Mechanical Addendum M-1

Date: August 30, 2023

Project: **Centre For Addiction and Mental Health
Move Consolidation – Interior Renovations**
250 College Street,
Toronto, Ontario,
M5T 1R8

Subject: Mechanical changes and/or additions

Sheet Title:
MECHANICAL NEW PLAN -
8TH & 9TH FLOOR

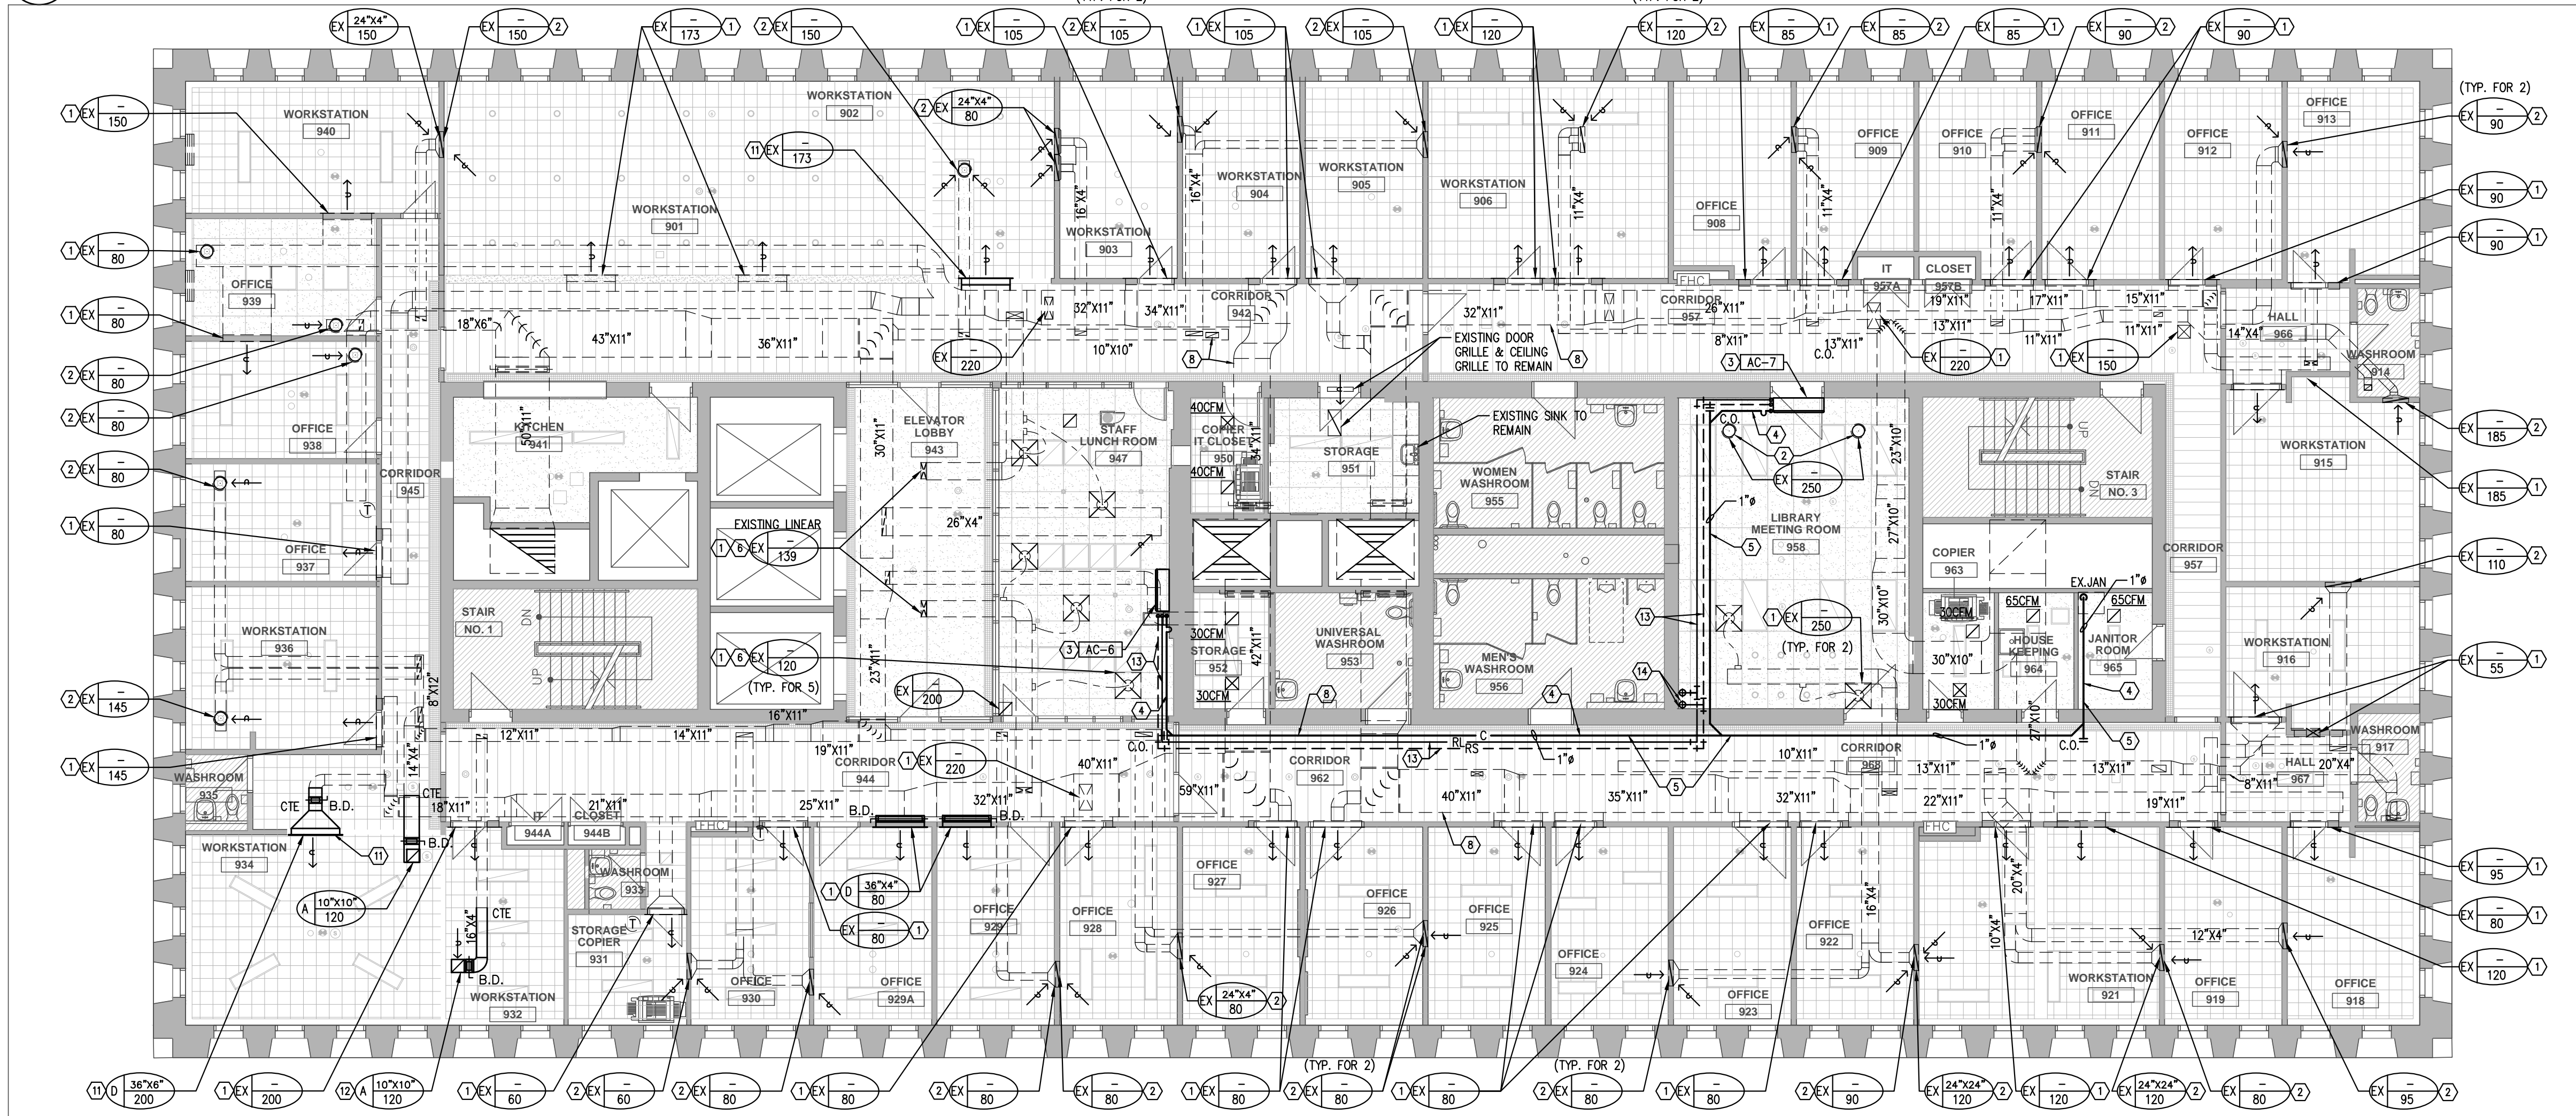
8. Drawing M-300, Mechanical New Plan – 8th & 9th Floor (Issued)

1. General Revisions have been made to the mechanical drainwg to delete the AC-8 on the 8th floor, revised refrigerant and condensate pipe routing on the 9th floor, deletion of hub drians, etc.

Sheet Title: MECHANICAL NEW PLAN - 10TH & 11TH FLOOR

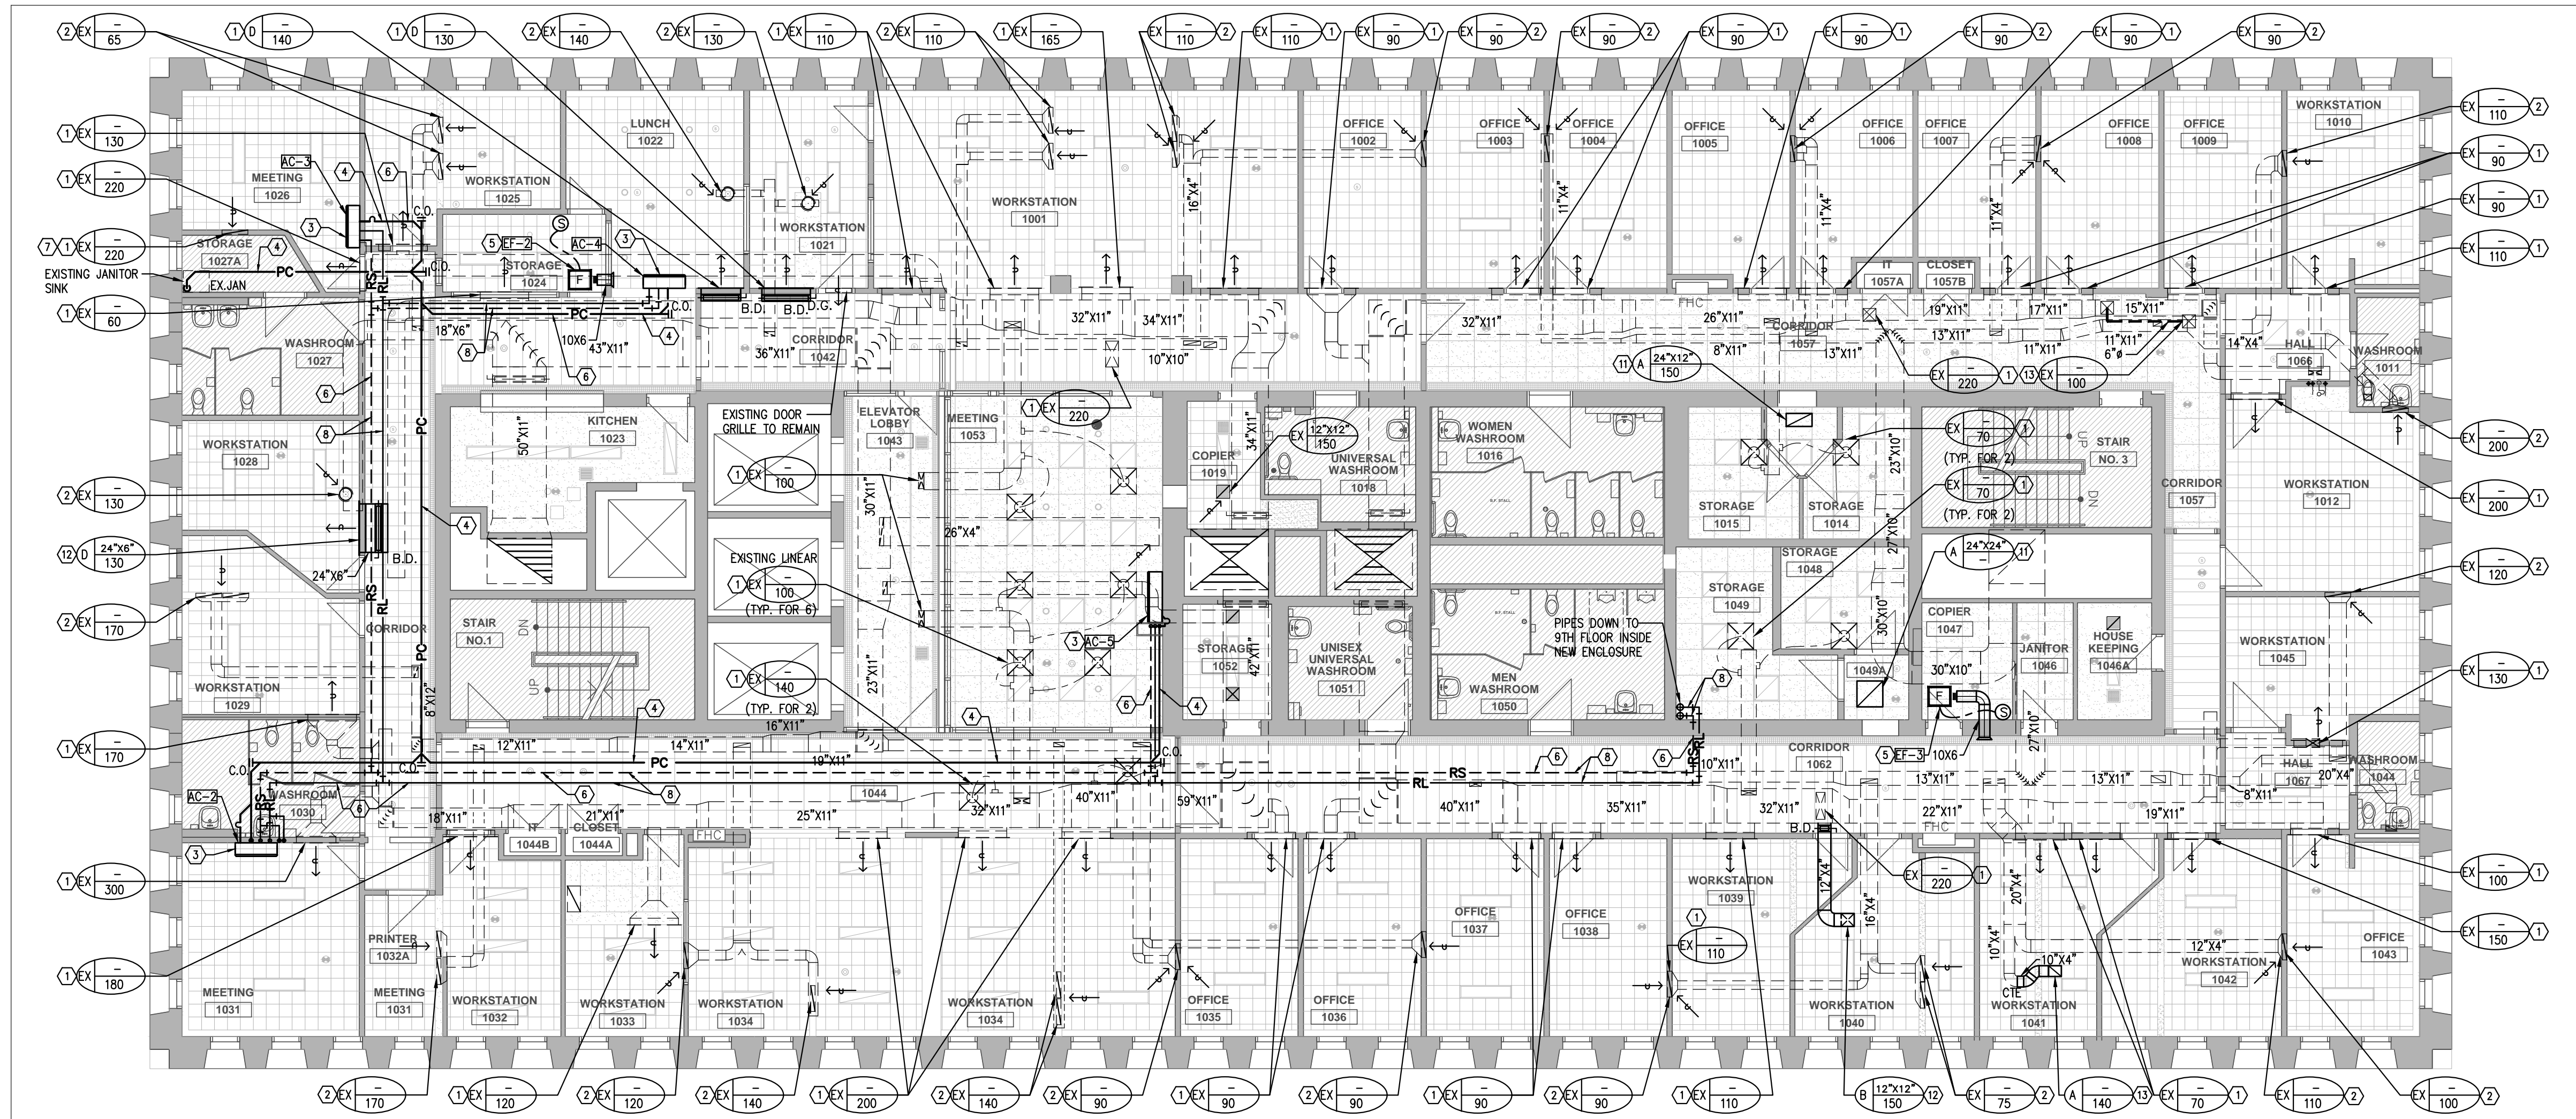
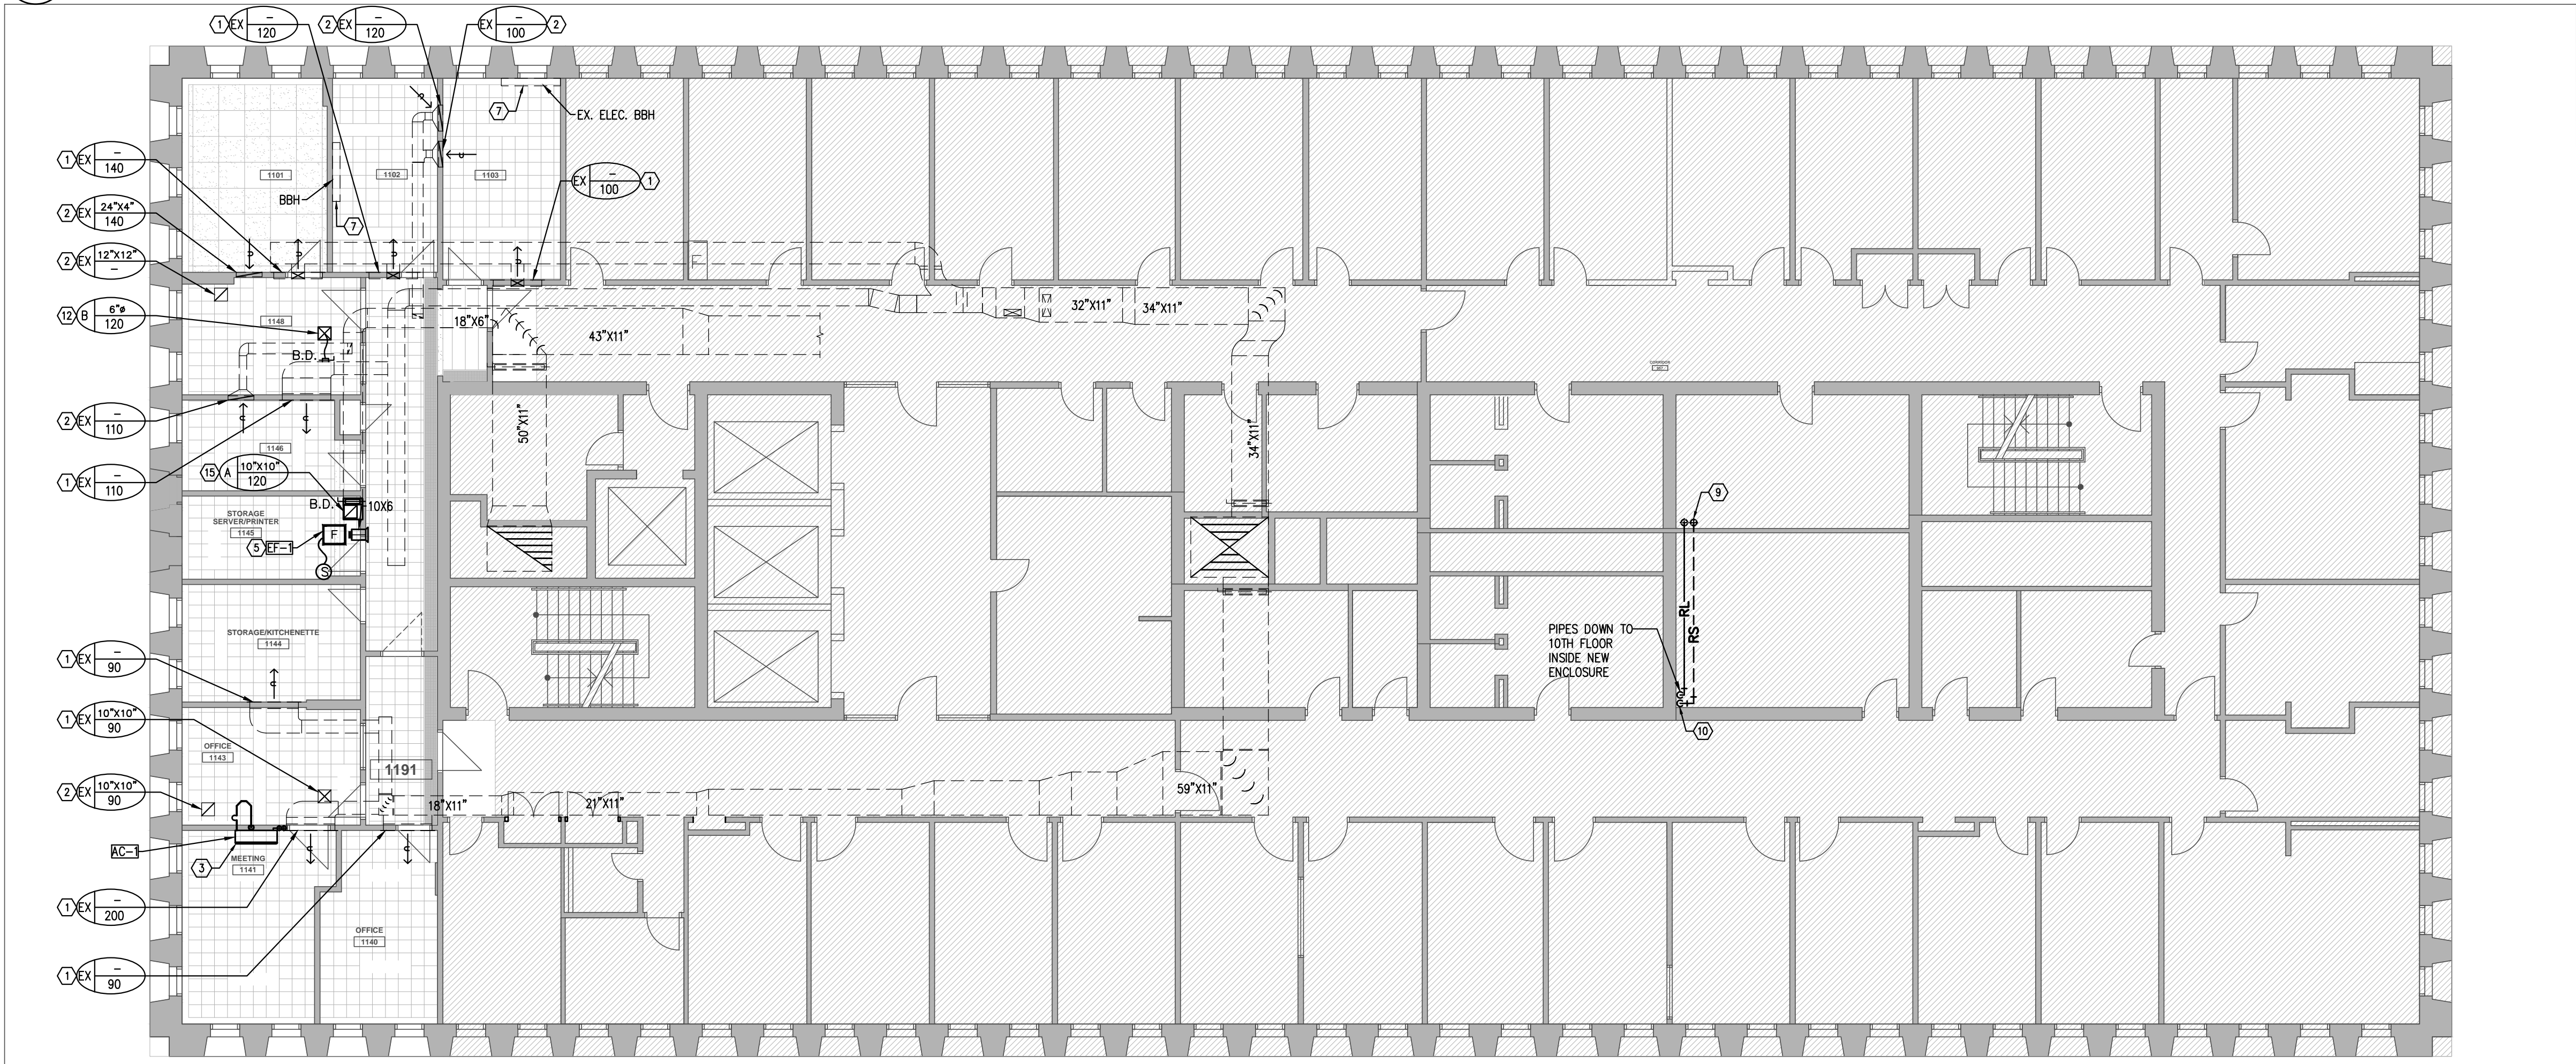
9. Drawing M-301, Mechanical New Plan – 10th & 11th Floor (Issued)

1. General Revisions have been made to the mechanical drainwg to indicate the revised refrigerant and condensate pipe routing on the 10th & 11th floor, deletion of hub drians, etc.
